**UPPER UWCHLAN TOWNSHIP
PLANNING COMMISSION
AGENDA
March 11, 2021
7:00 p.m.**

II. 164 Byers Road Preliminary / Final Land Development Plan

**RE: Preliminary/Final Land Development Plan Application:
QBD Ventures
Waiver Request Letter**

Reference: QBD Ventures
Preliminary/Final Land Development Plan
Upper Uwchlan Township, Chester County, PA

IMPROVEMENT CONSTRUCTION PLAN

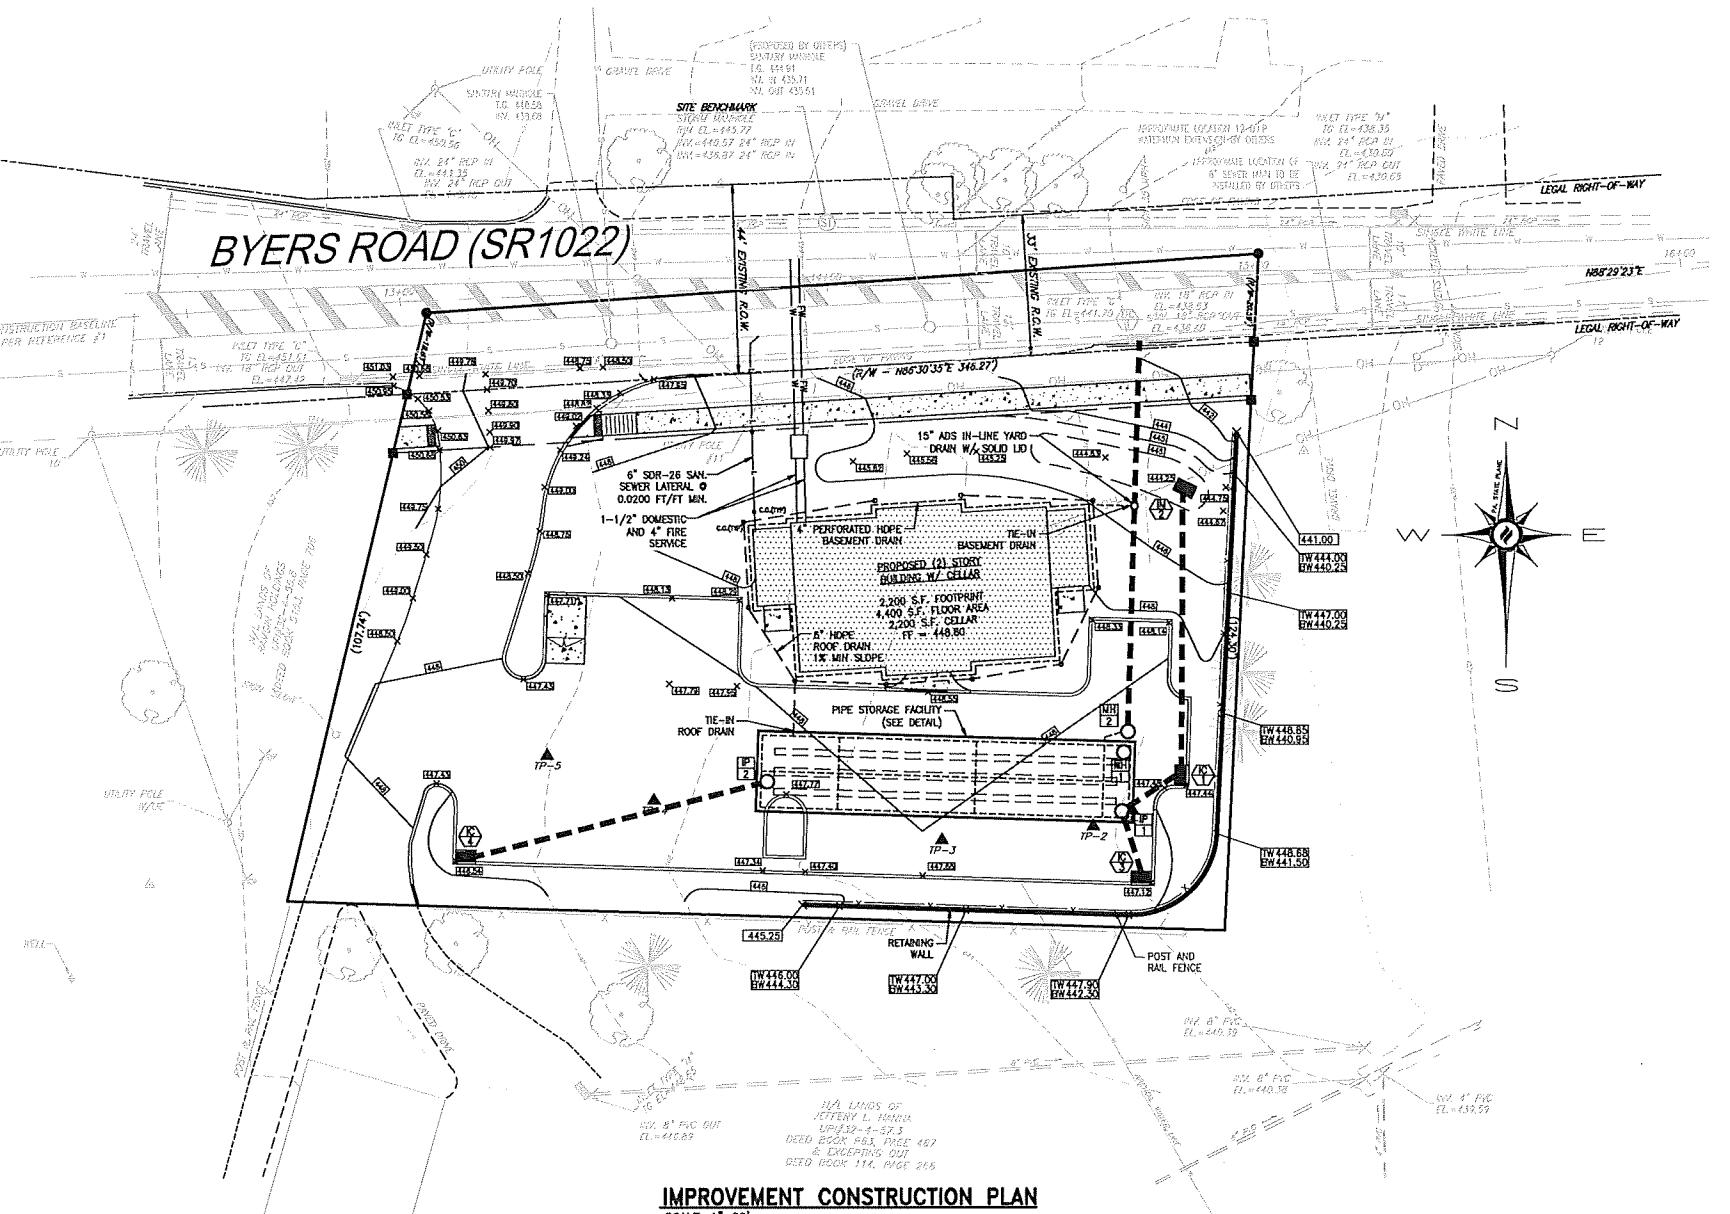
5. On Sheet 1, the notes listed under Waivers Requested are stated as waivers granted, and should be revised to state waivers requested.
6. Add parking stall lines on both sides of the parking island.

7. We recommend that the 3 foot radius on the southern parking lot end section be revised to be 5 feet and not 3 feet.
8. Identify or remove what appears to be errant symbols on Sheet 1, including the 9 enclosed in a circle on the sidewalk along the frontage, as well as the 10 and 12 encircled symbols.

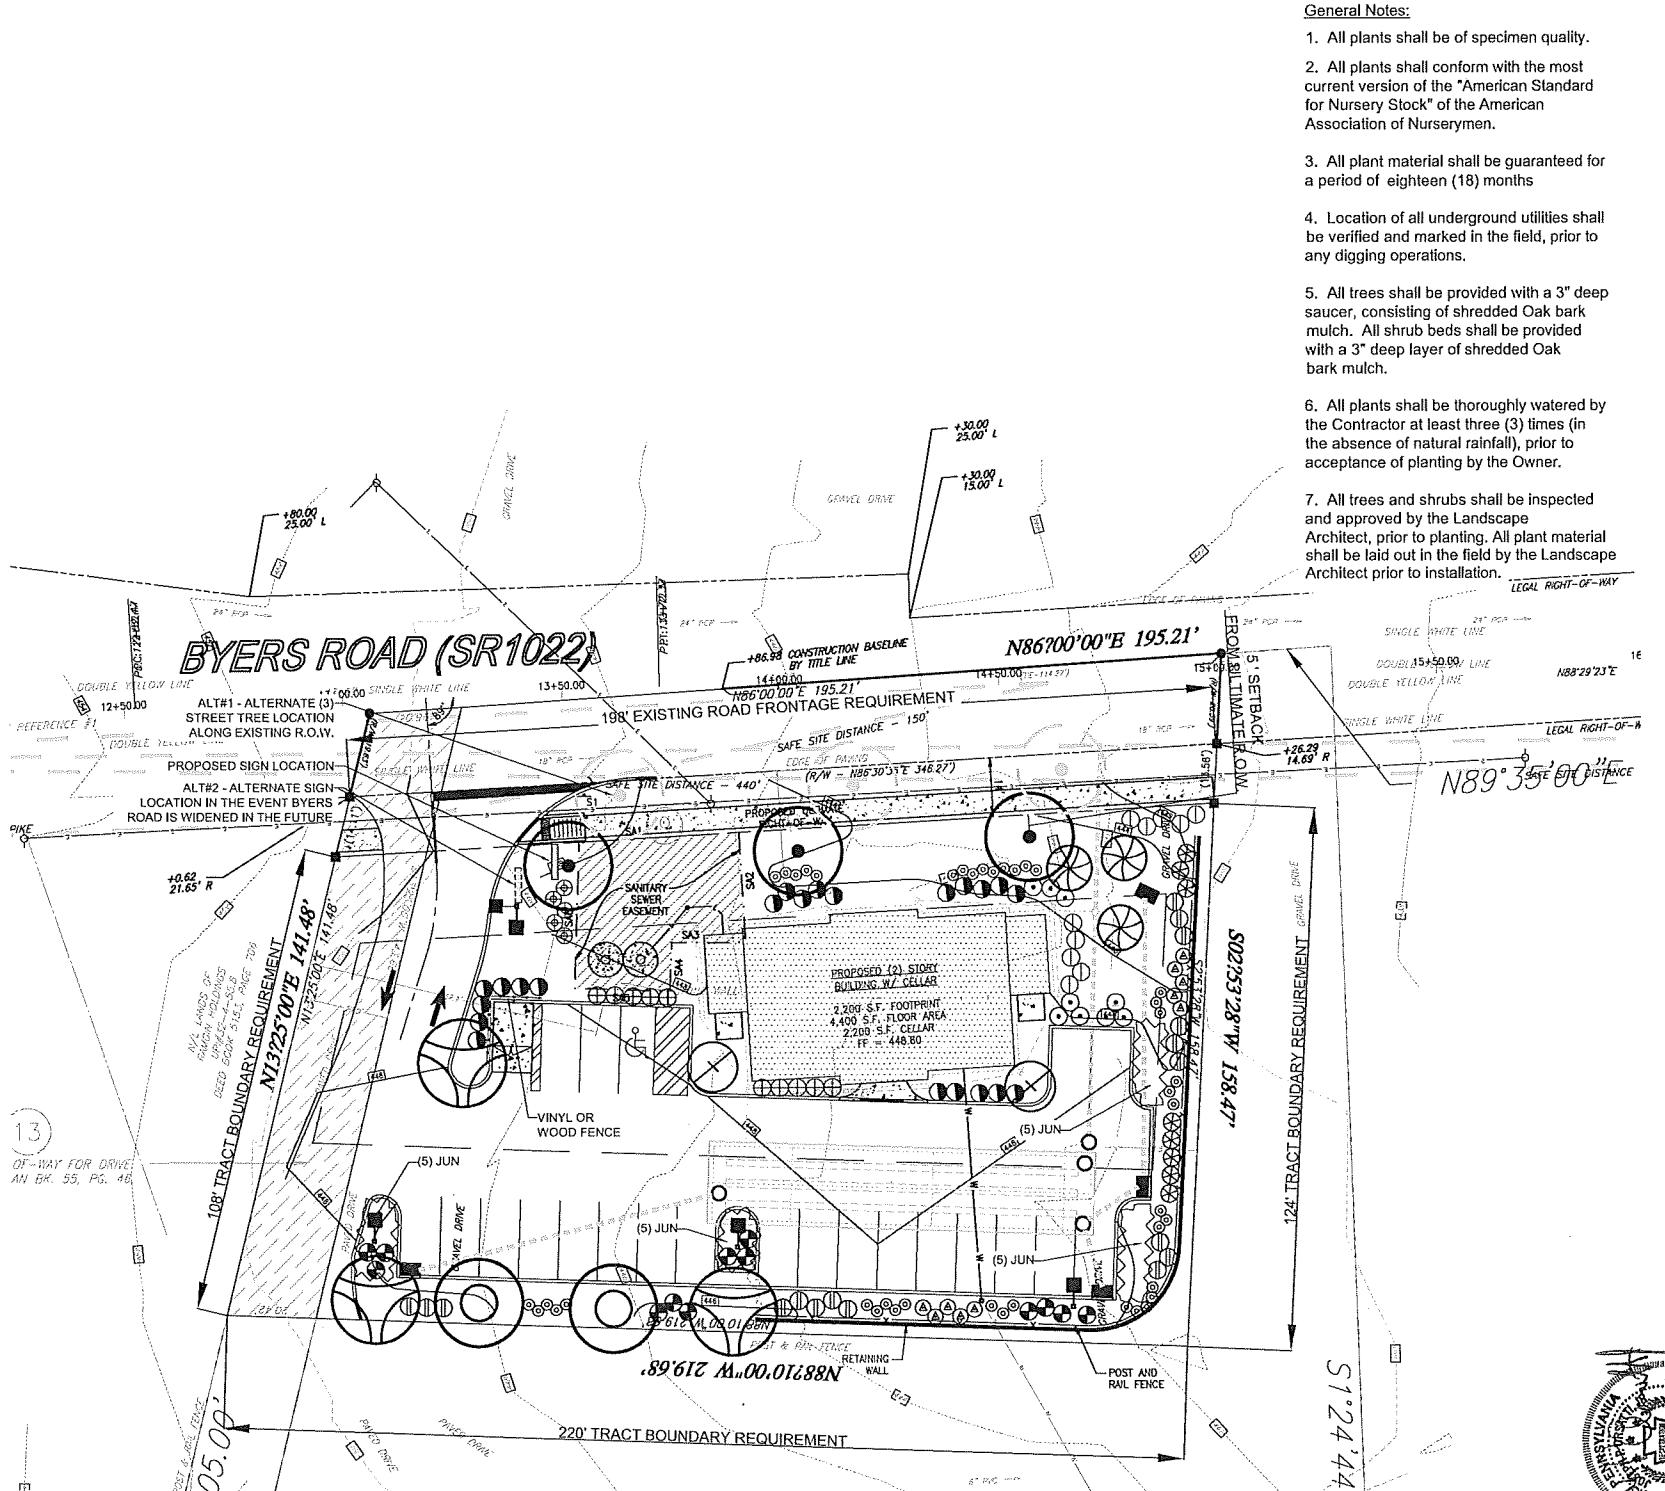
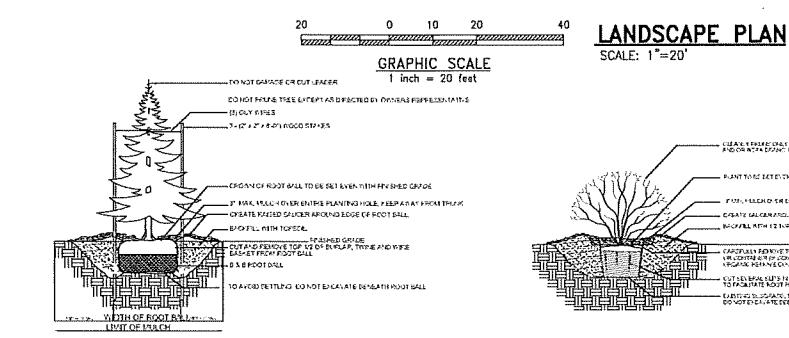
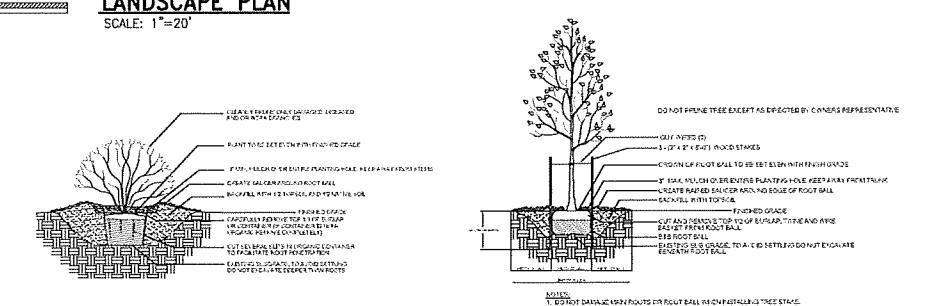
2. In our opinion, Sheet 10 Township Landscape Plan meets the intent of Section 162-57 of the Subdivision and Land Development Ordinance for landscape design and installation standards. The applicant has provided a detailed compliance chart on sheet 10 with waivers requested for plant quantities

required under Section 162-57. We support the applicant's waiver requests. The waiver requests should be added to Sheet 1 Title Plan.
